QC 326-06 Prime Outlets Parking
Site Plan 05-06-05-0012c

RE: File MASP #05-06-05-0012-C Project: Prime Outlets Overflow Parking

**RE: PRIME OUTLETS PARKING; QAC FILE #05-06-05-0012-C
McCCRONE, INC. JOB #D1060155**

SITE AND GRADING PLAN FOR
PRIME OUTLET PARKING
 TAX MAP 51 & 59, GRID 13 & 02, PARCEL 91 & P/O PARCEL 10
 5th ELECTION DISTRICT, QUEEN ANNE'S COUNTY, MARYLAND
 PREPARED FOR: PRIME OUTLET

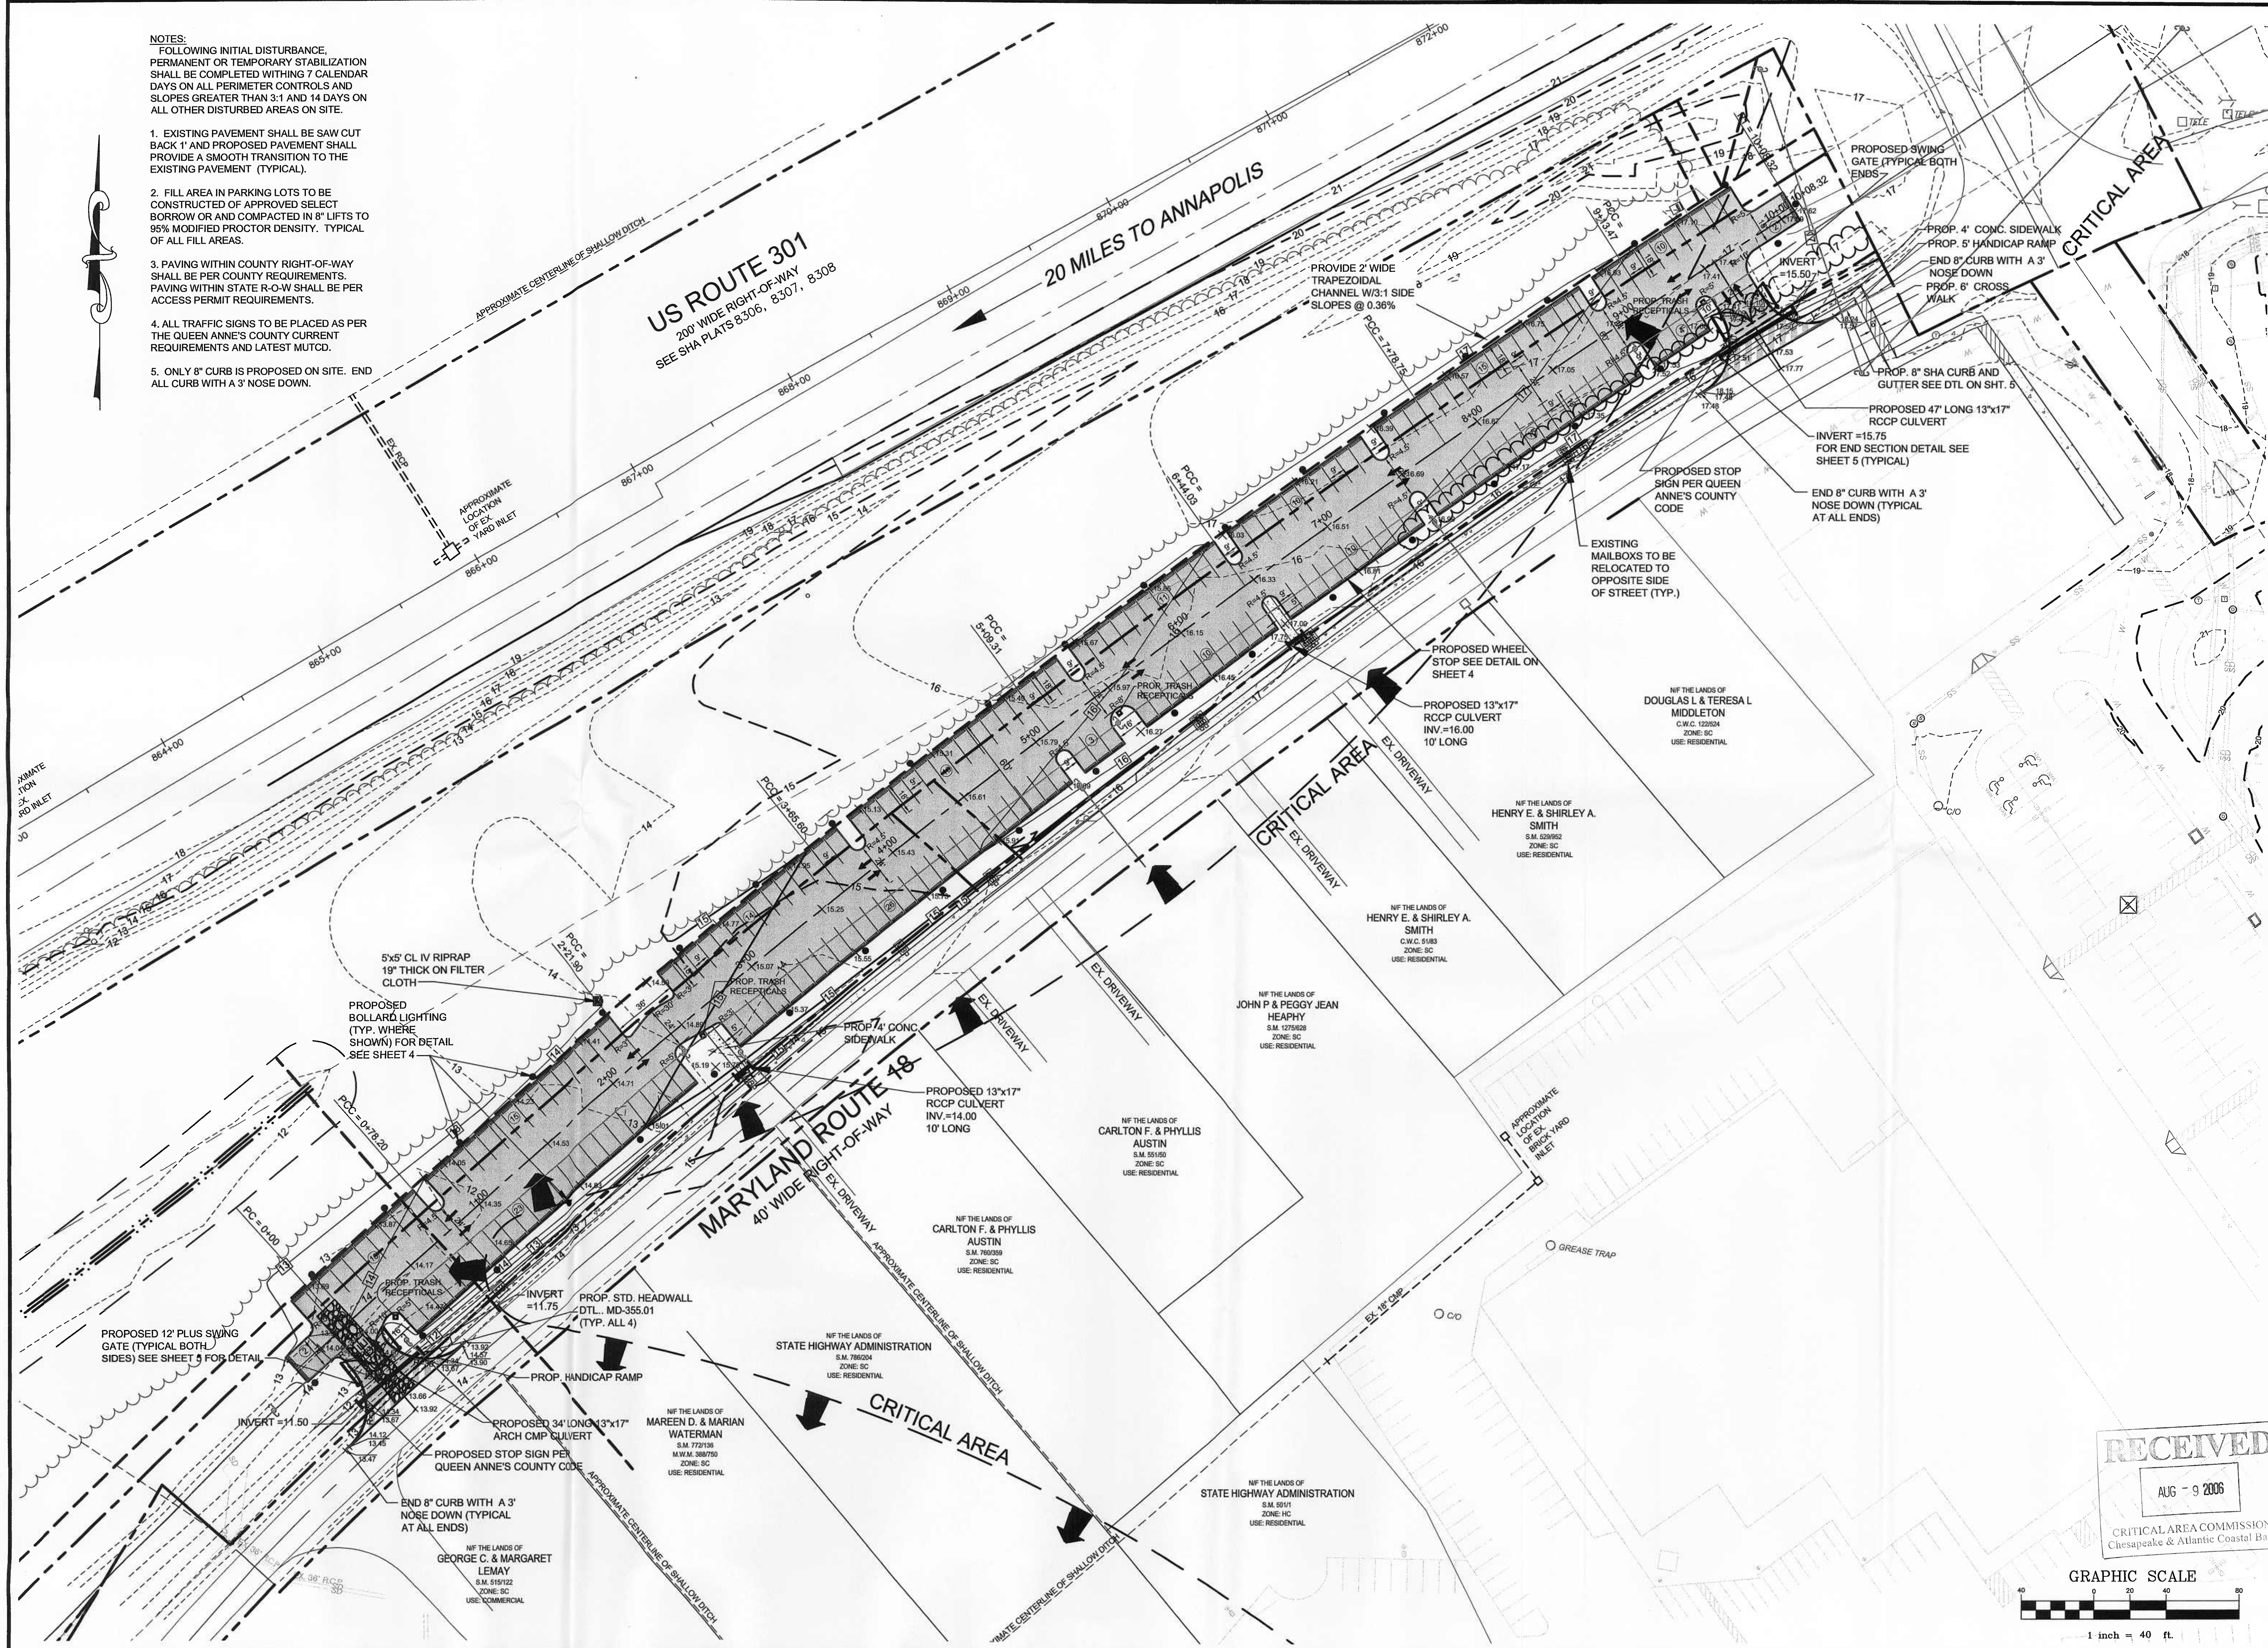
3. The site statistics on sheet 1 are confusing. It appears that the proposed impervious under site calculations are different from those noted under Critical Area impervious calculations, please correct.

12. In the Site Summary please add "of" before wetlands on Sheet 1.

13. The hatching noted on Sheet 1 does not match the hatching used on Sheet 2 for exiting condition to indicate the easements, please correct.

15. It appears that the Critical Area line pertaining to the northern area of the property has disappeared on Sheet 3, please replace.

16. On Sheet 2 it appears that a very small area is not in Critical Area, is this correct?

32. Please address how stormwater is to be managed on the site in notes on Sheet 1.

Response: The Site Statistics include both impervious area permitted in Critical Area as 15% and Suburban Commercial Zone (non-critical area) as 45% permitted.

Response: This has been revised as requested.

Response: The hatching color was changed to reflect the legend.

Response: The site is shown in its entirety on sheet 2. Sheet 3 and 4 show the site at a larger scale for clarity.

Response: This observation is correct. Upon closer review the Critical Area was previously shown incorrectly. The Site Area calculations for Critical and Non-critical area have been added to the cover sheet.

Response: A Stormwater Management note has been added to cover sheet.
